Application No.: 09/753,764

Amendment After Allowance dated: November 11, 2005

AMENDMENTS TO THE DRAWINGS

Application No.: 09/753,764
 Amendment dated: November 11, 2005
 Reply to Notice of Allowability dated: October 21, 2005
 ANNOTATED SHEET SHOWING CHANGES

FIG.2 (PRIOR ART)

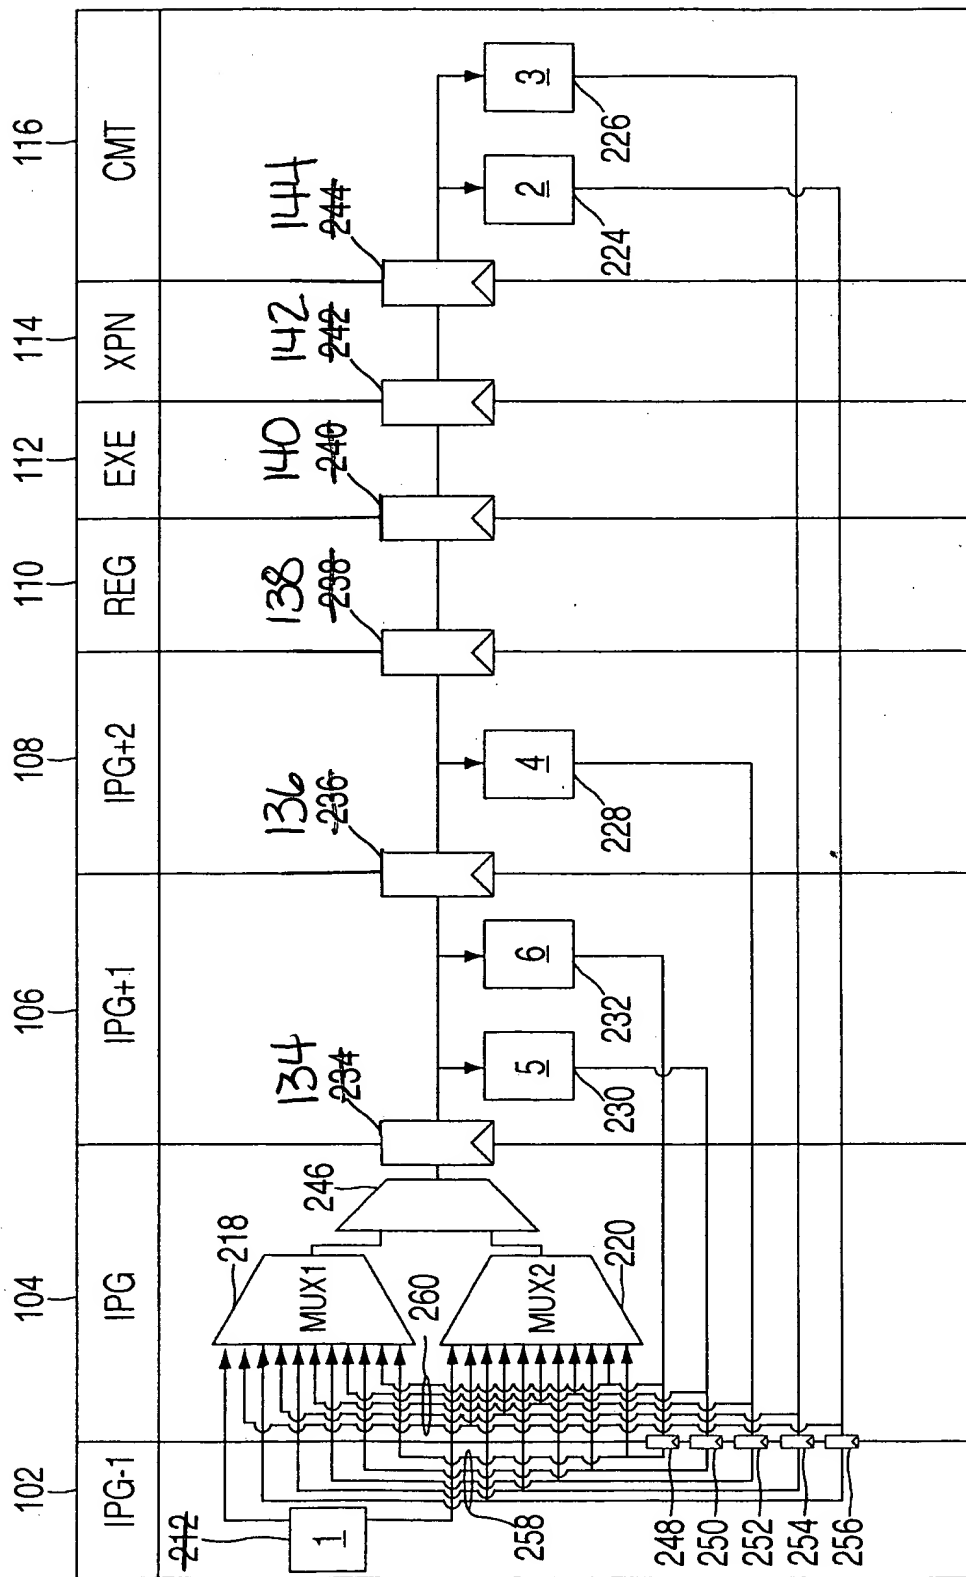
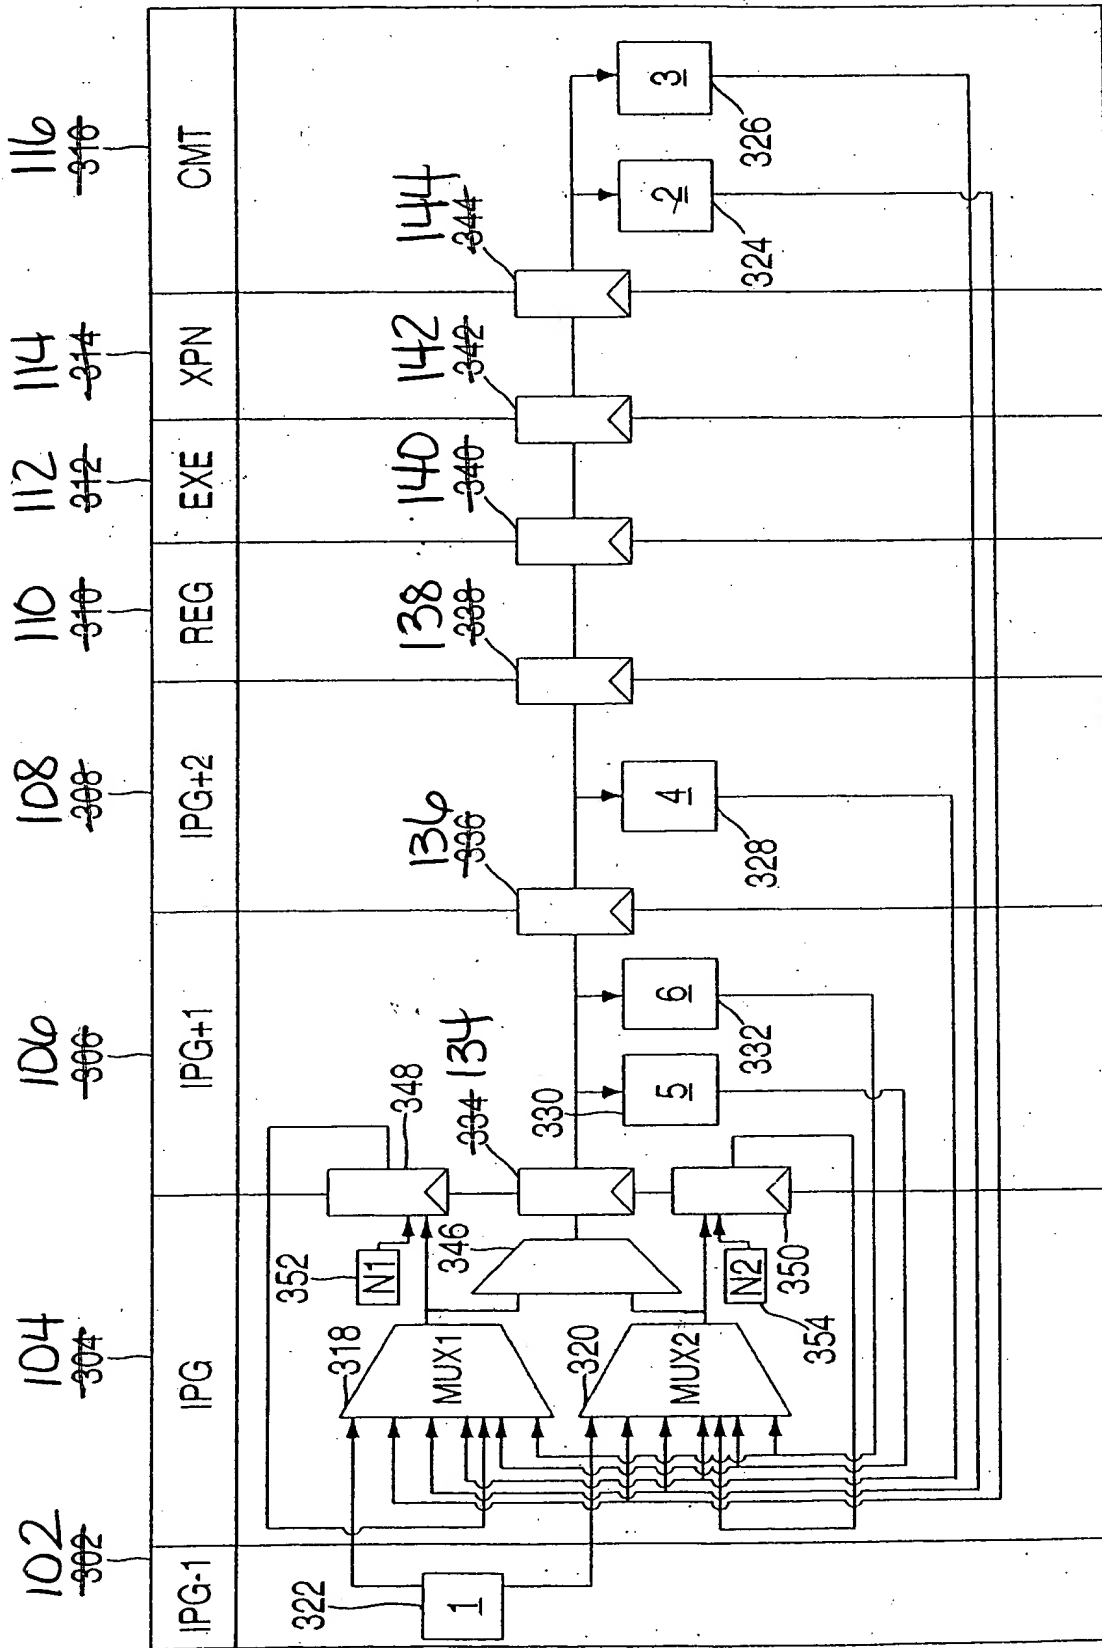
Figures 2 and 3 have been amended to comply with the Examiner's request in the Notice of Allowability dated October 21, 2005.

Therefore, Figures 2 and 3 have been amended per the Examiner's request in the Notice of Allowability dated October 21, 2005. Replacement sheets of Figures 1-4 are also being submitted with this amendment.
